**OLD RECHARGE BASIN
SITE NO. 1-52-004
EAST FARMINGDALE, NY**

DEMOLITION AND FILLING WORK PLAN

RE: Fairchild Old Recharge Basin Site No. 152004
Demolition and Filling Work Plan, October 1996

Re: Old Recharge Basin Site
Site No. 1-52-004
East Farmingdale, NY

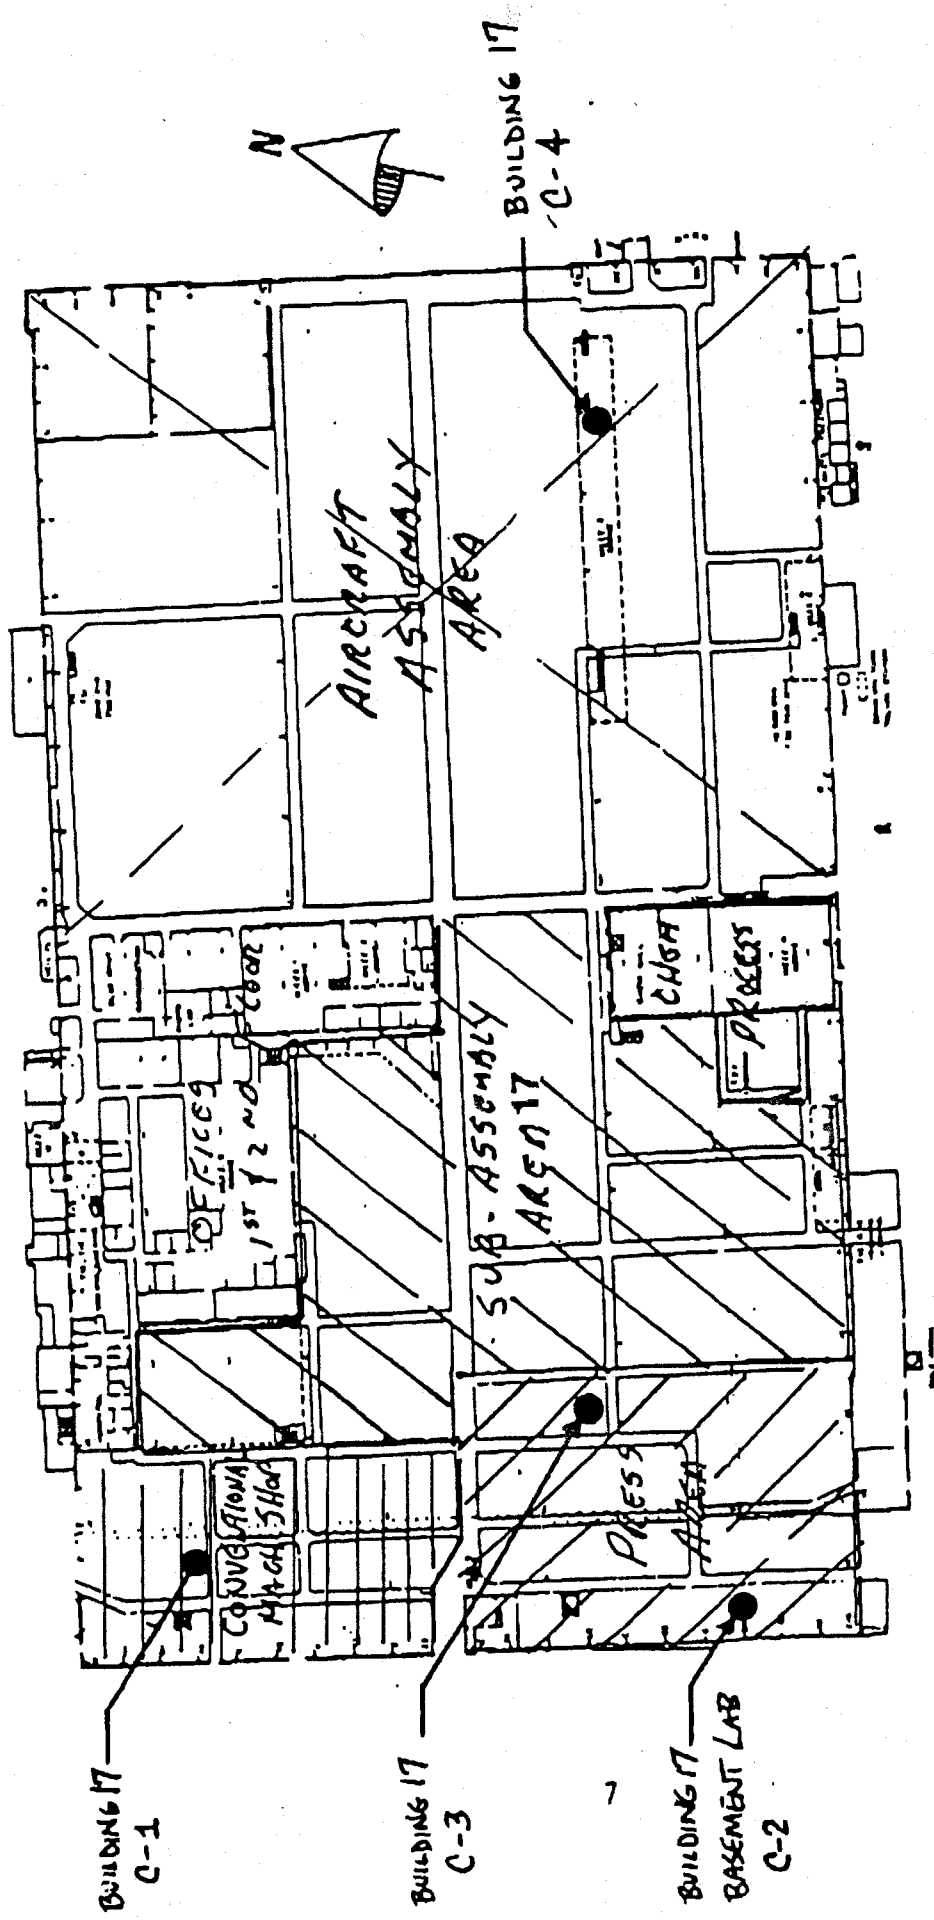
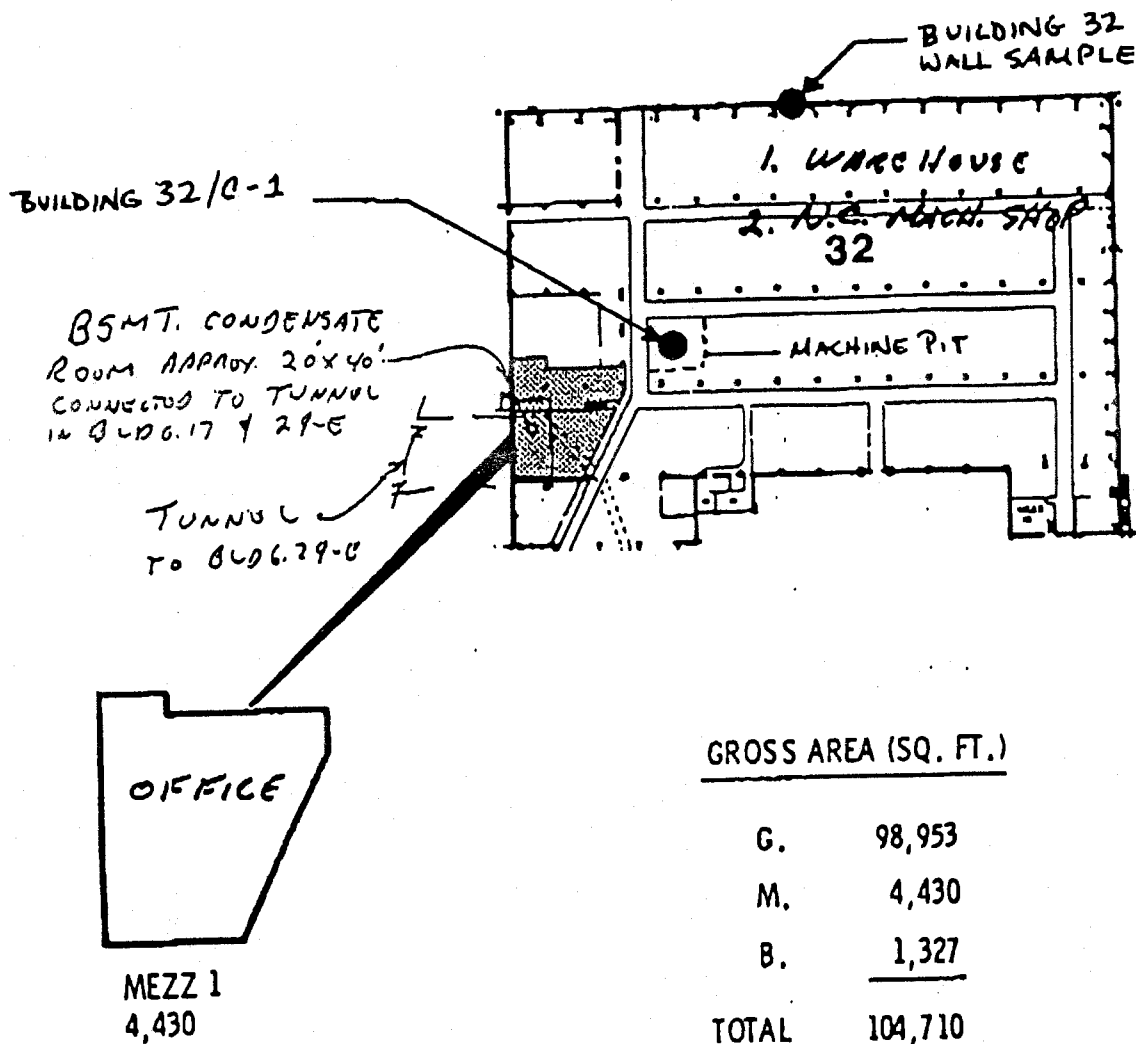
7. **Page 5, Sampling Plan - Please reference that the locations of the samples collected are shown on Figures 1, 2 and 3.**

This reference has been added to the text.

APPENDIX 1
FILL CALCULATIONS

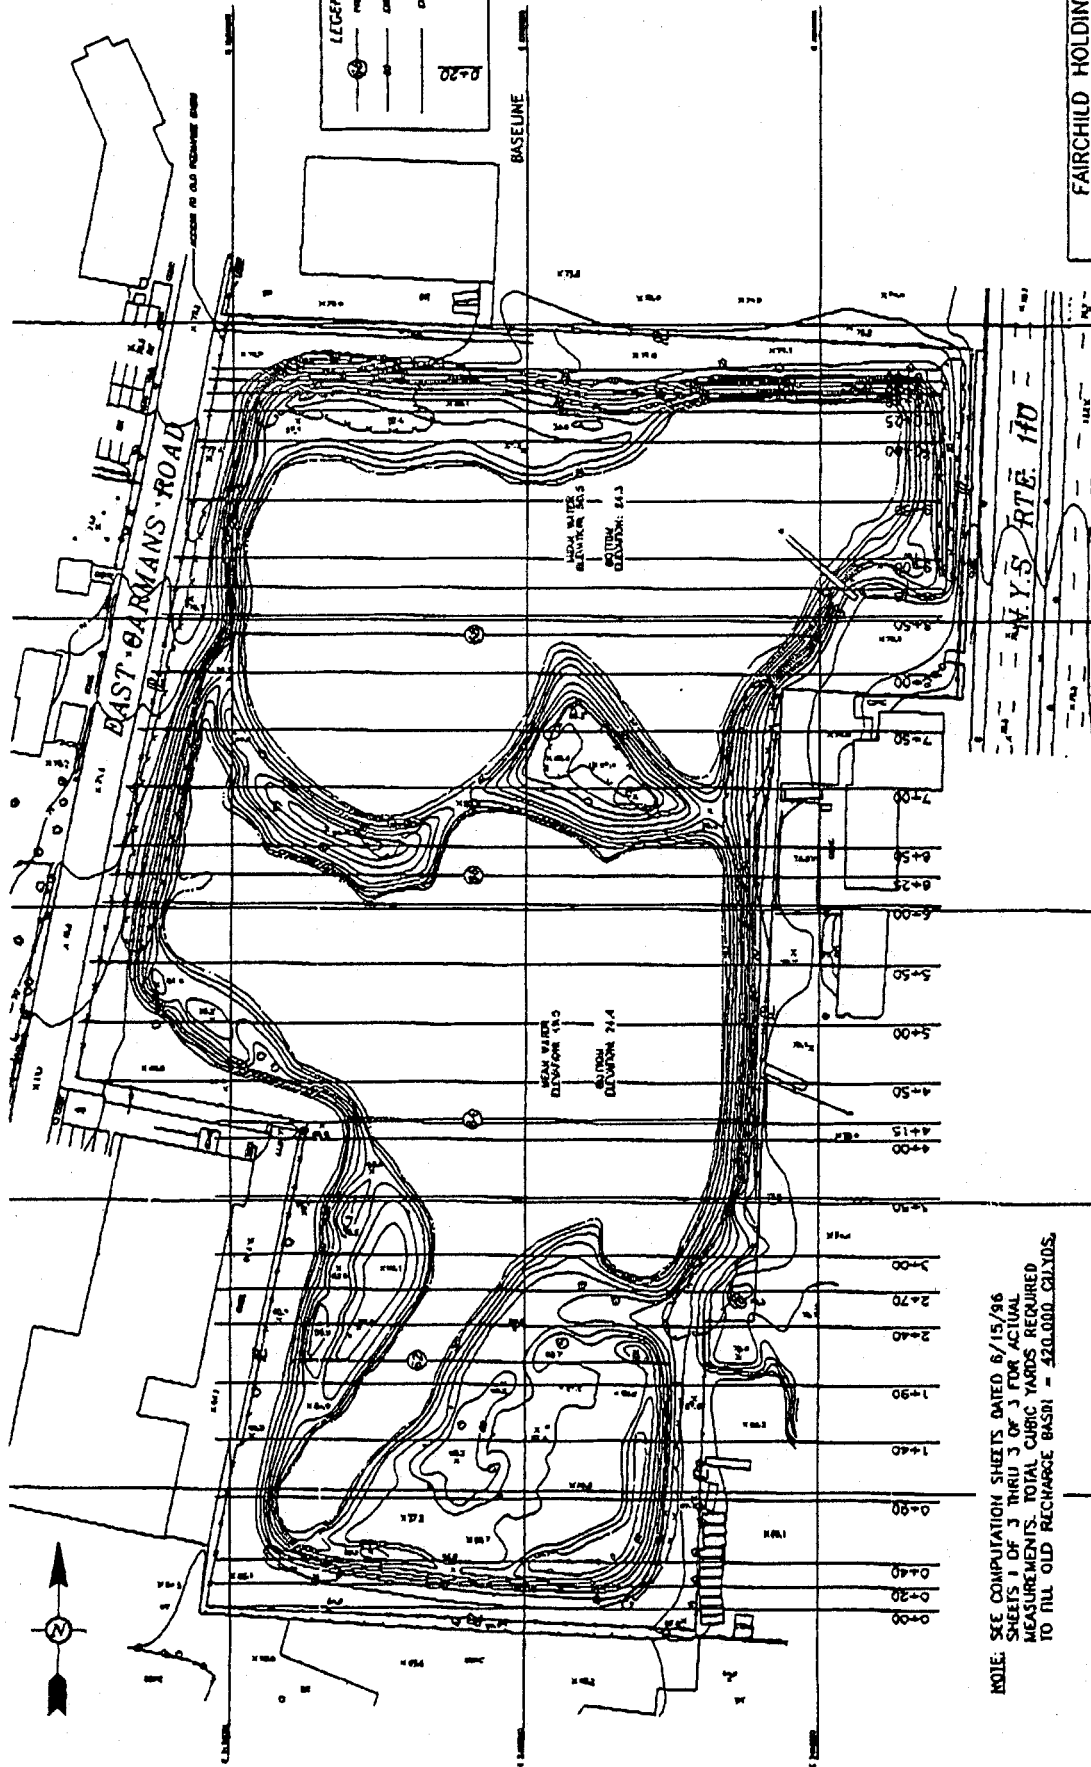
2. **Material Calculations - The calculations for granular material (soil) and asphalt are not given in enough detail to support the quantities shown. Please provide more detail in Appendix 1 and on Sheet 2 (similar to those calculations for the amount of fill needed for the ORB).**

Further detail has been provided in Appendix 1 and on Sheet 2.
